Design Advisory Board

Tuesday, February 24, 2026, 3:00 PM

To: The Design Advisory Board
From: Mary O'Neil, AICP, Principal Planner
RE: ZP-25-622
Location: 37 Archibald Street
Date: February 24, 2026

To: The Design Advisory Board
From: Mary O'Neil, AICP, Principal Planner
RE: ZP-26-28
Location: 45 Howard Street
Date: February 24, 2026

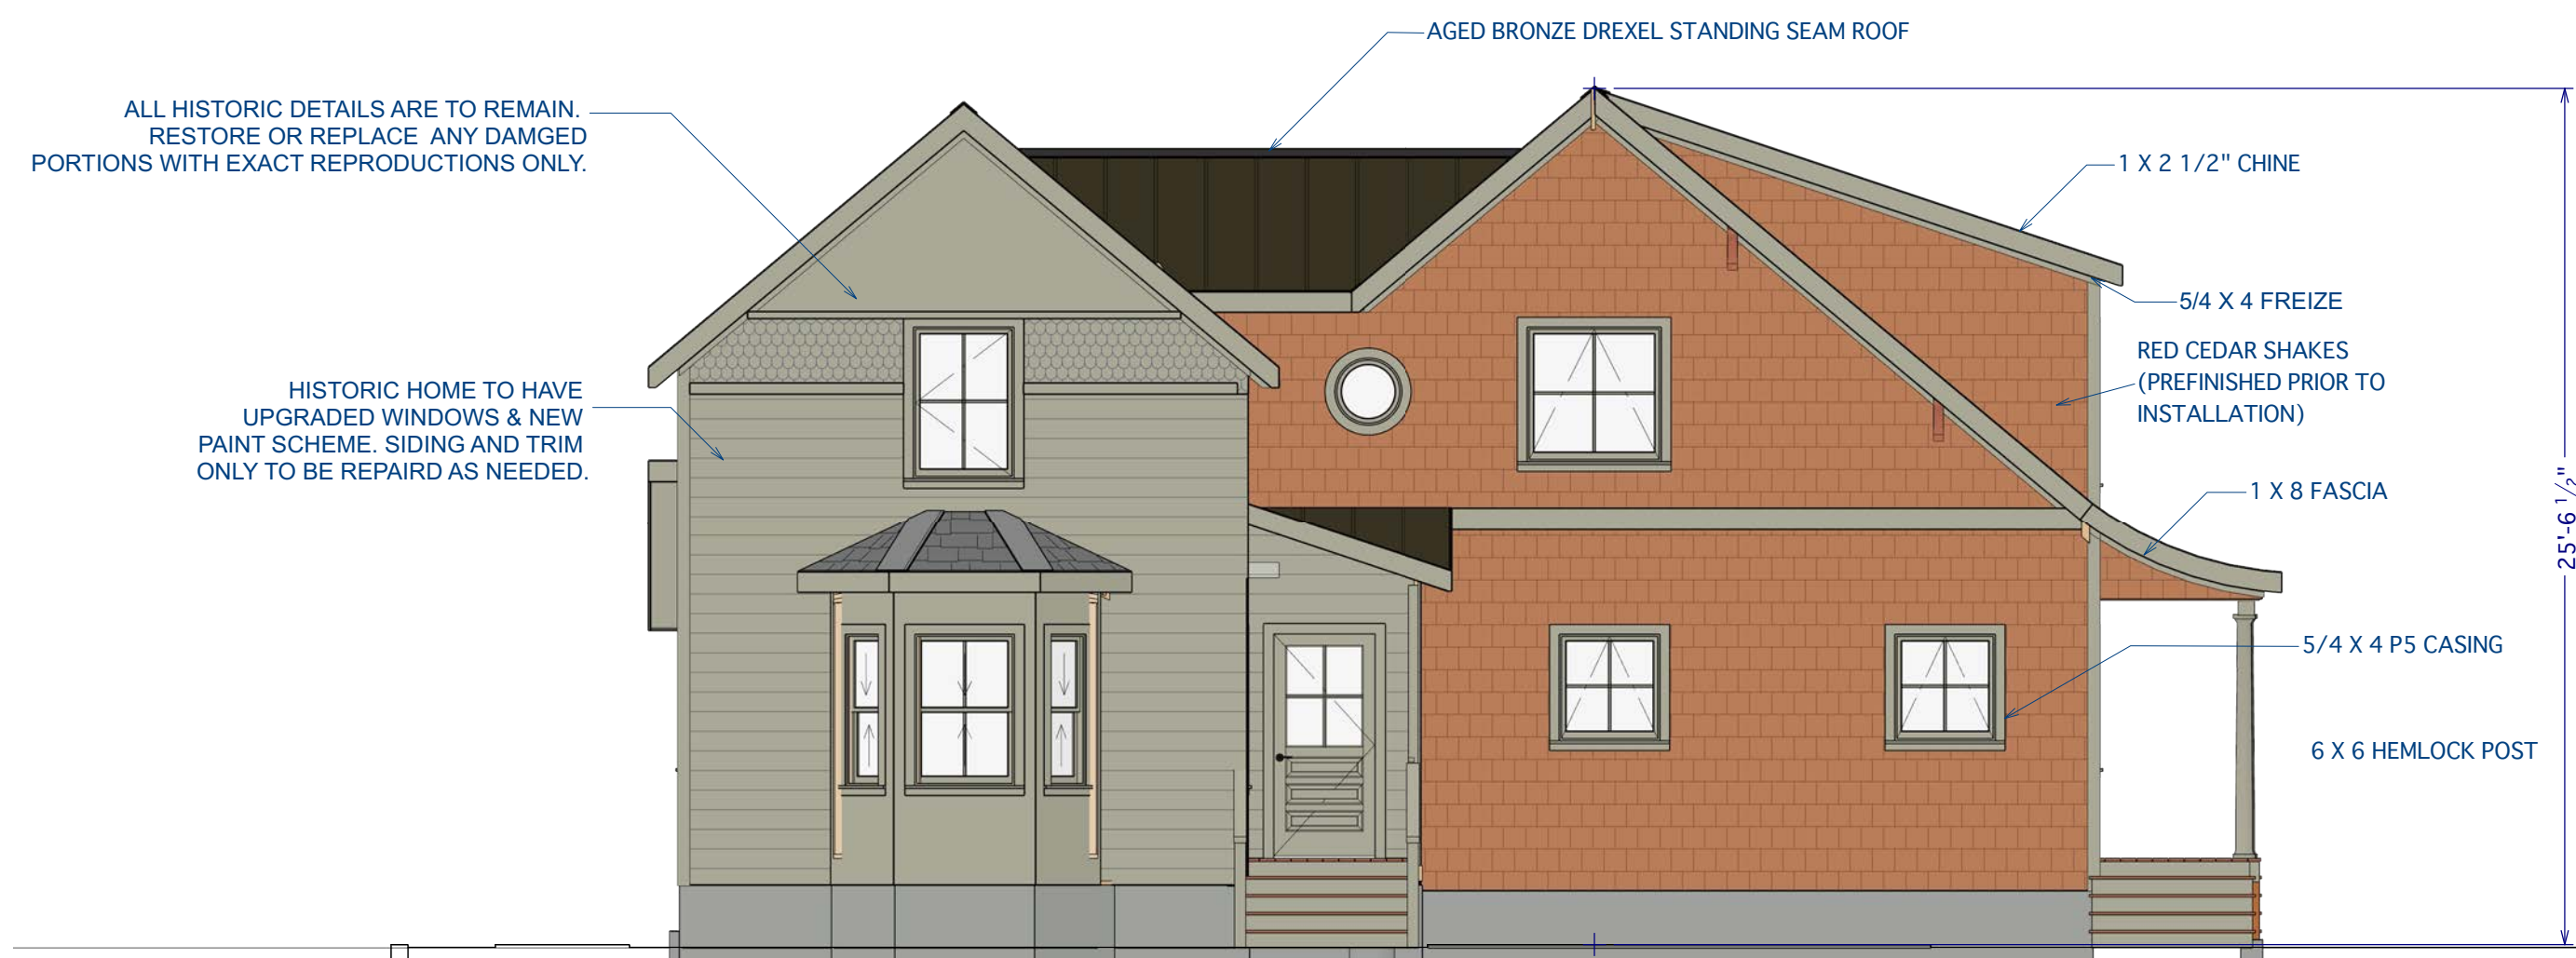
While it may be possible to remove the addition in the future, the surface contact forfeits the side porch and the details on the westerly side of the original home.

SITE & DISTURBANCE PLAN

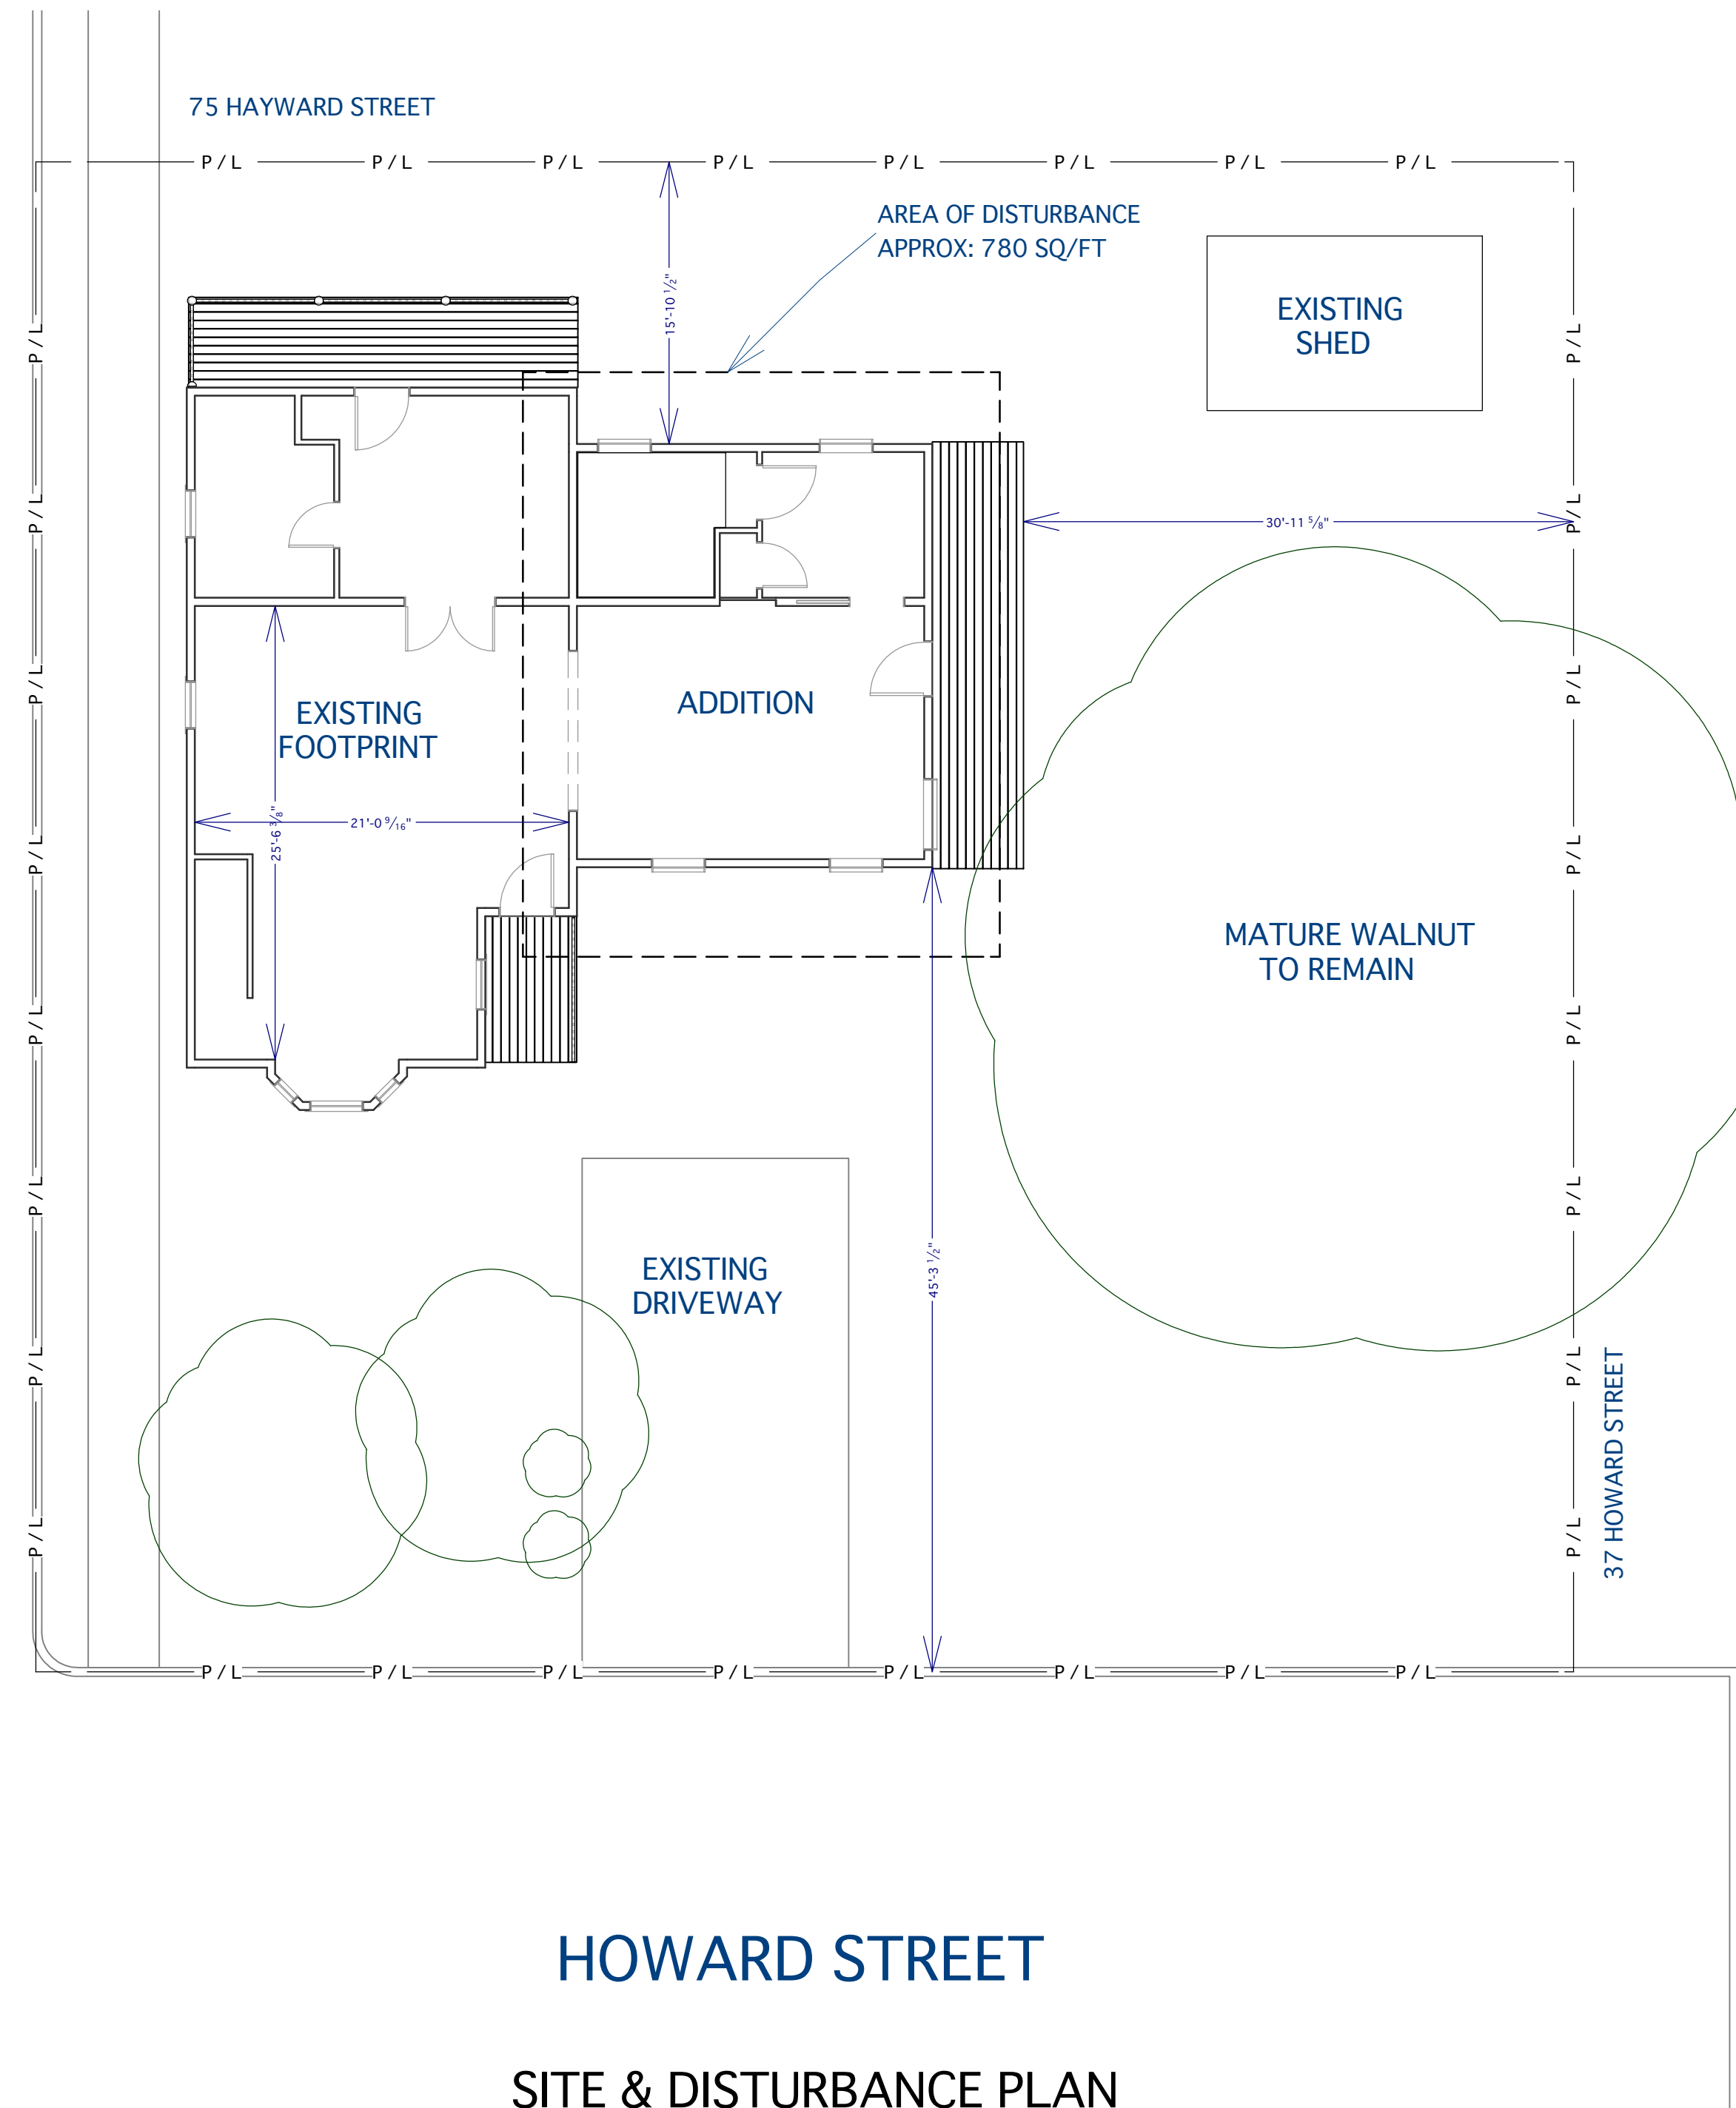
Sheet 1 of plans defines that landscaping is the obligation of the property owner; however, a landscaping plan is required for review. Additionally, any tree cutting shall be identified.

The site plan defines an area of approximately 780 sq. ft. of disturbance. An Erosion Prevention and Sediment Control Plan is required for review and approval by the Stormwater Engineering division. Submittals define *all finish grades shall be smooth and uniform.*

The application does not define any change for the existing driveway. The site plan appears inaccurate, as street images illustrate the driveway extending beyond the porch (another vehicle is parked there). The site plan shall be corrected to accurately display the area and measurements of the surface parking.

The submission does not define any changes to the existing surface parking. As noted, it must be accurately reflected on the site plan.
